GW - 001

**GENERAL
CORRESPONDENCE**

RE: Updated Discharge Plan
for Plateau, Inc.

**DISCHARGE AND MONITORING PLAN
FOR A REFINERY
OPERATED BY PLATEAU, INC.
NEAR BLOOMFIELD, NEW MEXICO**

Figure 6. Detail of sump construction

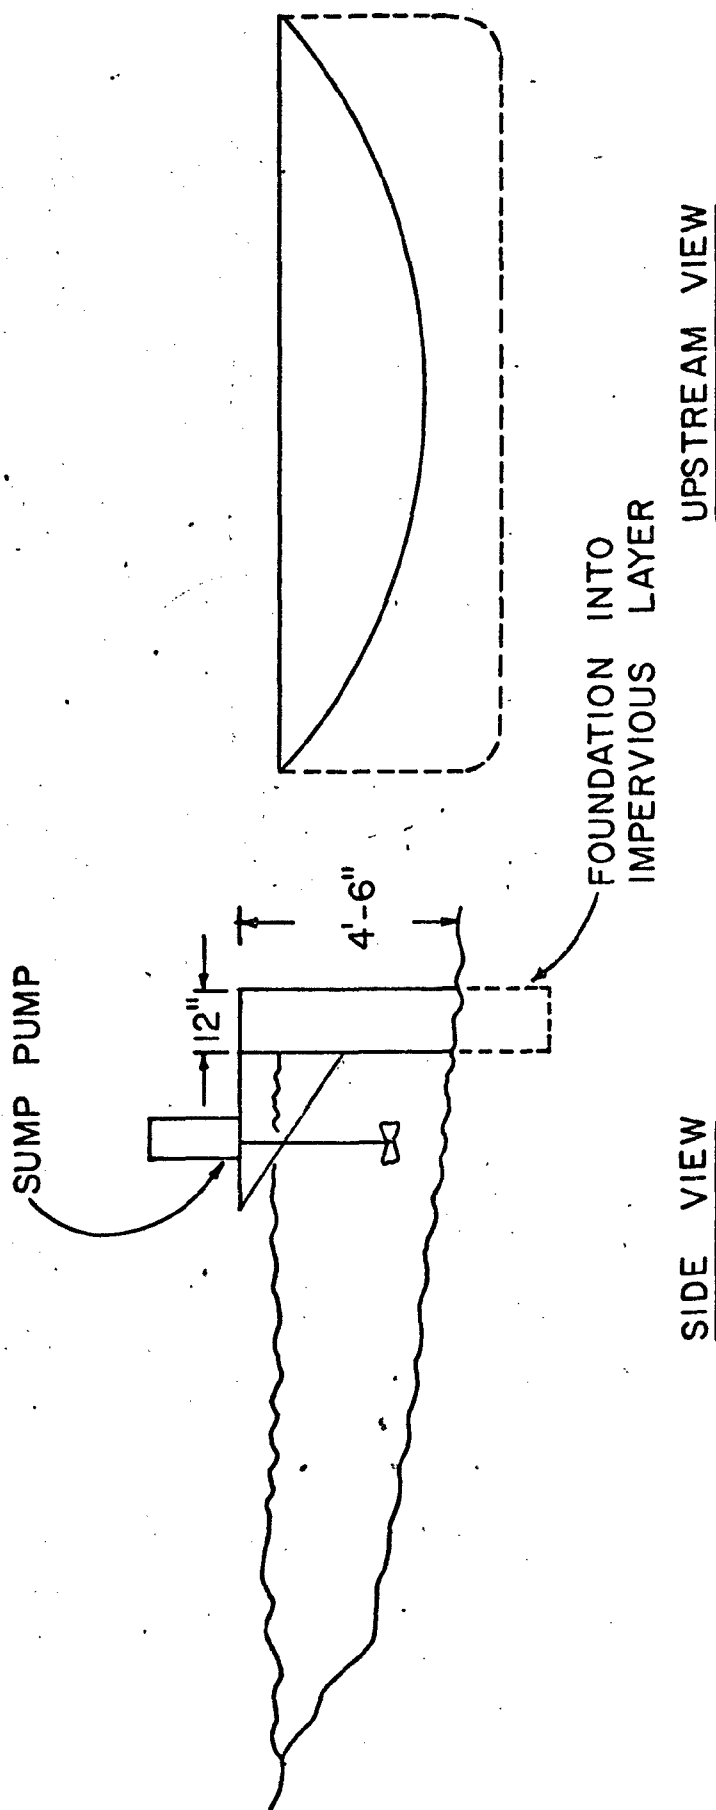
- 8) Submit diagrams illustrating the construction of the concrete dams and pumping systems to be installed on the north side of the plant and show the location on aerial photos. Submit a written explanation of how this system will function.

and from there into the San Juan River. To provide absolute assurance that all waste water will not escape from the refinery to pose a human health hazard or a salinity problem in a tributary to the Colorado River, low concrete dikes will be constructed across the arroyos to capture any waste-water seepage. Figure 6 is a schematic diagram showing typical construction details of these dikes. The dikes will be set in a foundation of impermeable Nacimiento Formation. Drain lines will run from each of the impoundments to a main gravity drain line which will extend along the grade of the San Jaun River to a point due north of the fresh water ponds. At this location, all captured water will be discharged into a sump from whence it will be pumped up to the fresh water ponds of the refinery. The grade of the San Juan River in the vicinity of the refinery has been determined by San Juan Engineering and is 0.0006667. To determine the ability of polyethylene pipe to transport the seepage water, use is made of the Manning equation. Results are given in Table 10.
